Special Use Permit (SUP) Application Report

RE: Administrative Approval (COA-137360-2023) for 3820 Hermitage Road– New Garage material specifications

Site Plan
 3820 Hermitage Road - Detached Garage Plans
 Manuchehr and Rebecca A Amirsoleimani
 City of Richmond, VA

Building Permit - Approved Construction Documents
Under general authority of the Building Code, this approved set of construction documents shall be kept on the job site at all times and shall not be altered without approval from the Building Official. This permit does not approve any Electrical, Mechanical or Plumbing work. This approval does not relieve the builder from complying with manufacturer instructions, Virginia Uniform Statewide Building Code and City of Richmond regulations whether noted, implied or omitted. Approved Plans: 20231117_3320 Hermitage Rd. BLDR-126560-2023 12/13/2023 11:20:35 AM

2 Section 4
1/4" = 1'-0"

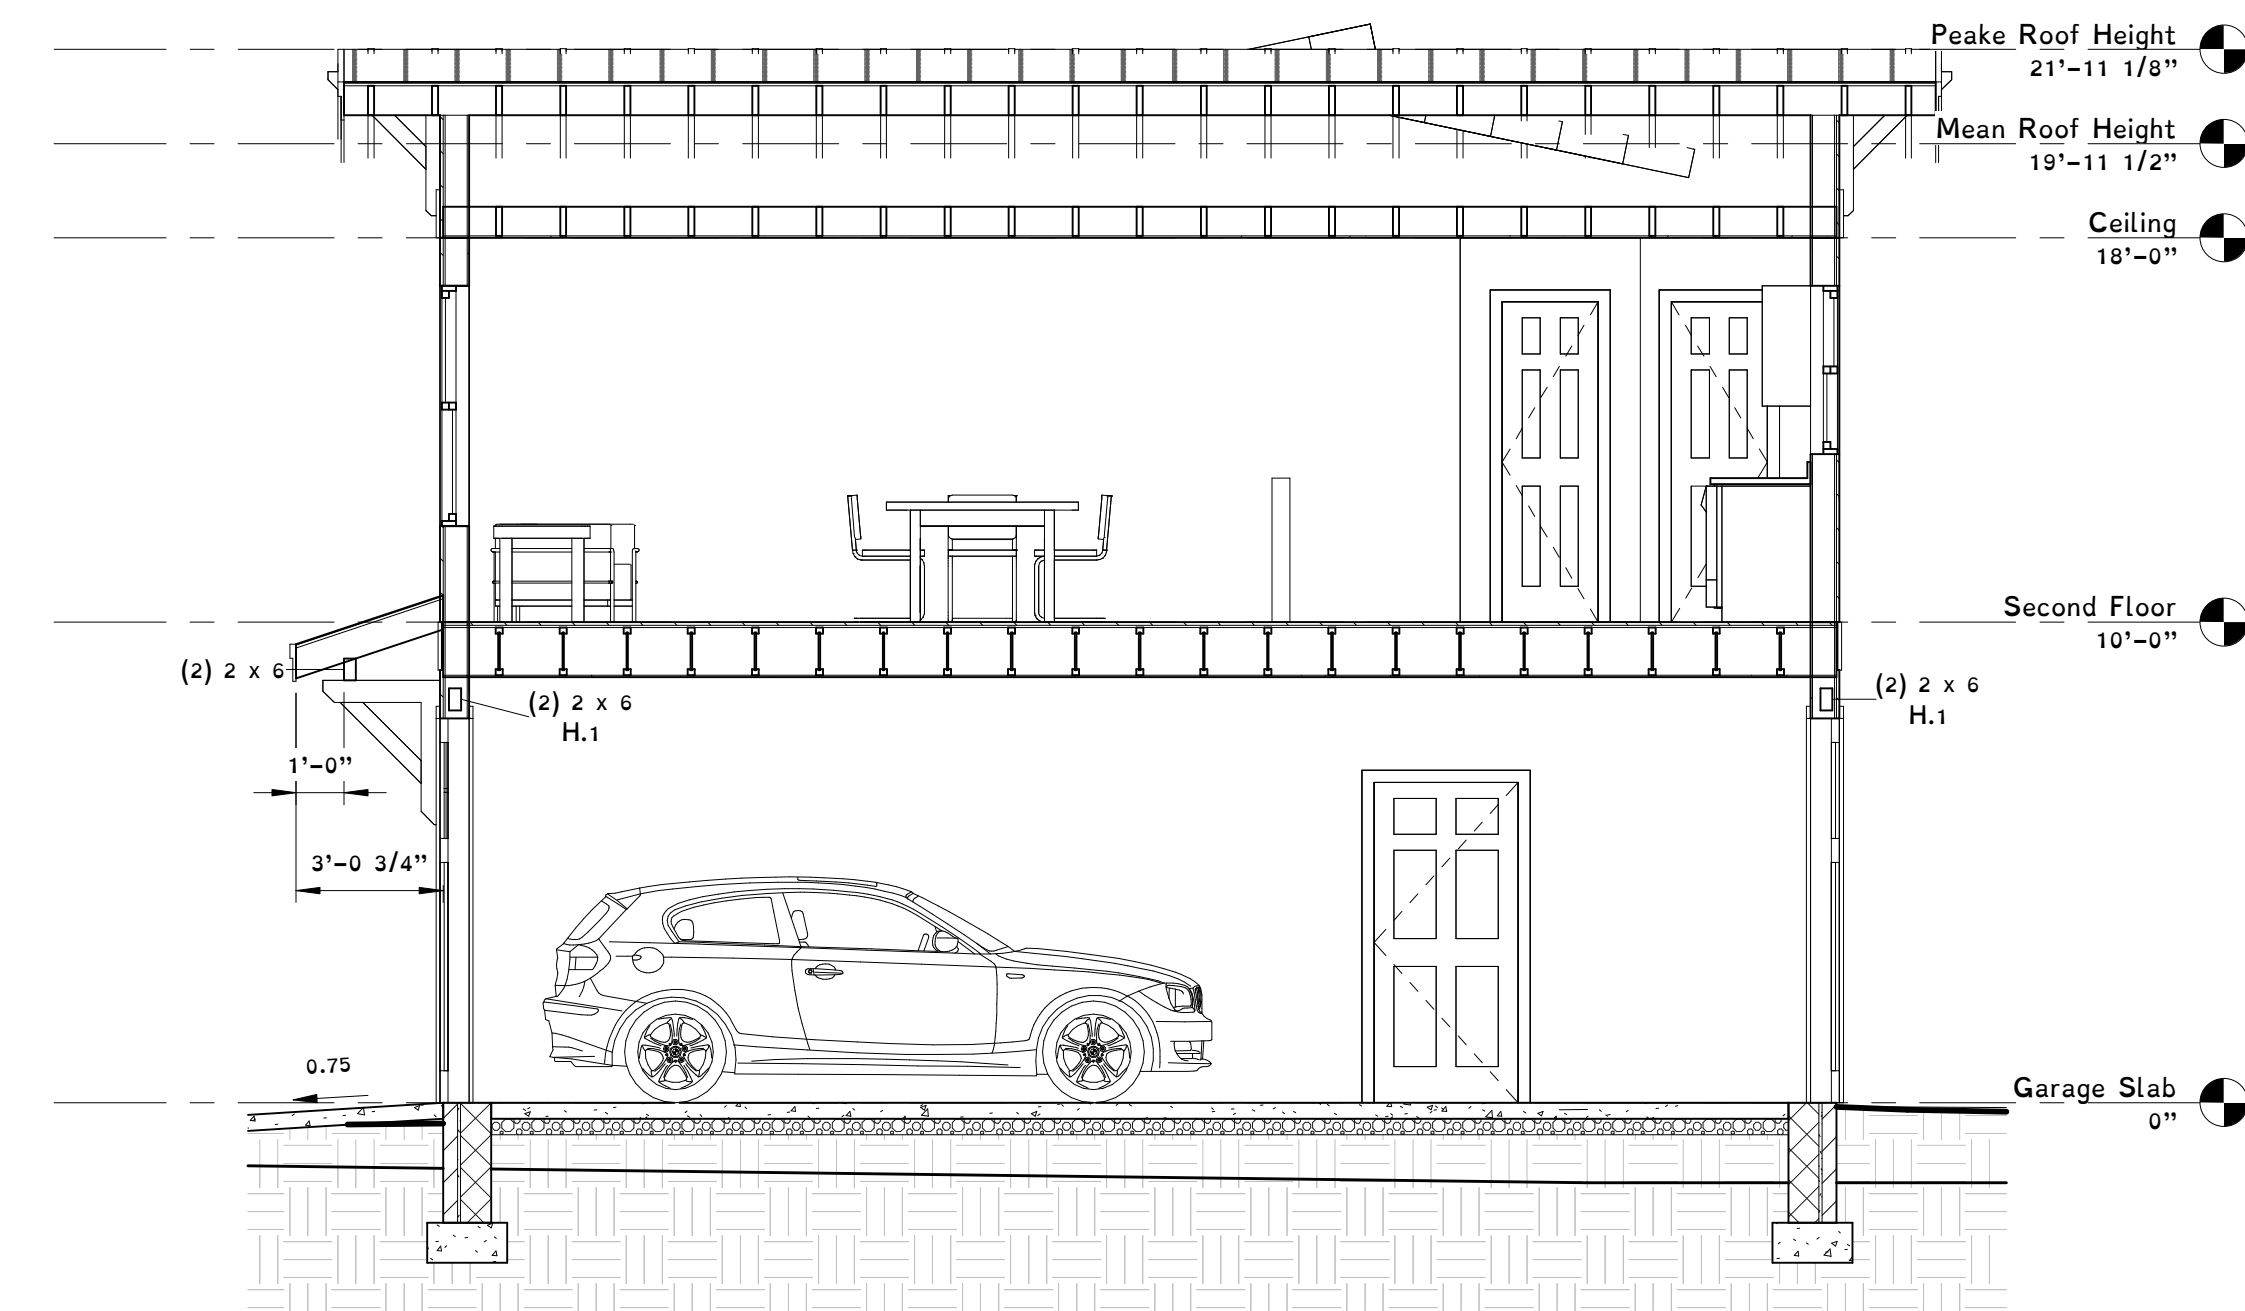
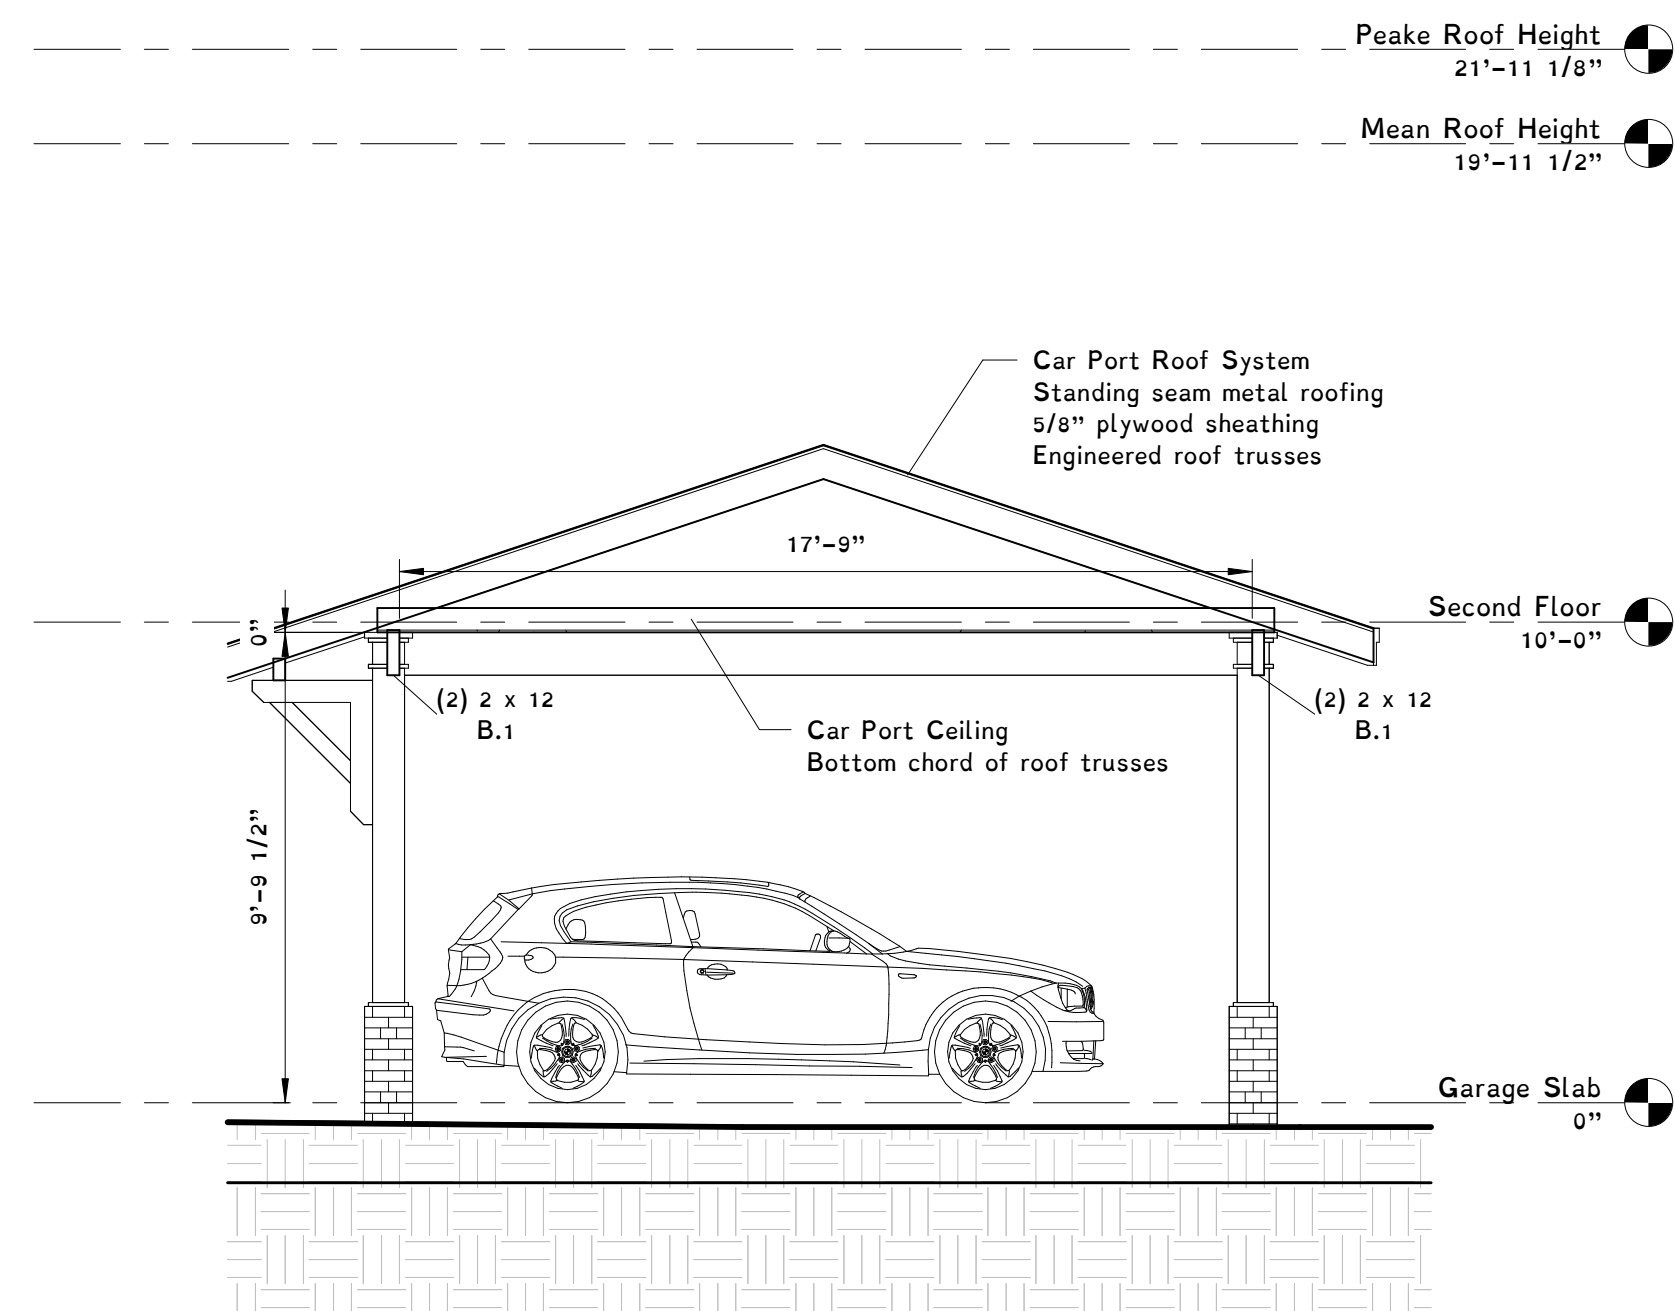
Per Section and Table R302.6 in the 2018 Virginia Residential Code the garage must be separated from habitable rooms above with not less than 5/8" Type X gypsum board or equivalent.

Per Section R403.1.4.1 in the 2018 Virginia Residential Code, except where otherwise protected from frost, foundation walls, piers, and other permanent supports of buildings and structures shall be protected from frost. This can be accomplished by extending the footing below the frost line (18" in the City of Richmond).
